AMENDMENTS TO THE DRAWINGS

REMARKS

In re Application of:
 Heikkila
 Serial No. 10/659,412
 August 28, 2007
 Annotated Sheet
 Showing Changes

FIG. 1

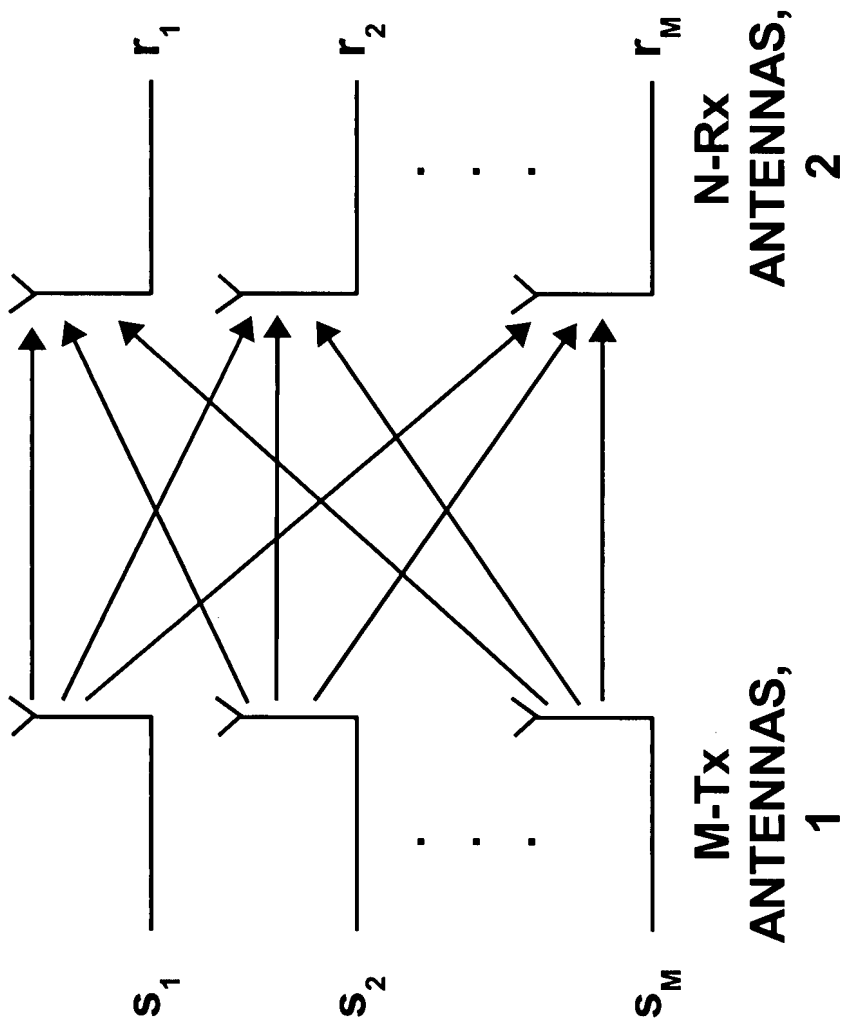
The attached drawing sheet includes changes to FIG. 1. This sheet, which includes FIG. 1, replaces the original sheet including FIG. 1. In FIG. 1, the caption "Prior Art" has been added.

As set forth on page 2 in paragraph 2 of the May 29 Office Action, the Examiner objected to FIG. 1 and required that a legend such as "Prior Art" be added to the figure.

Applicant has amended FIG. 1 to add the caption “PRIOR ART”.

Added
 PRIOR ART
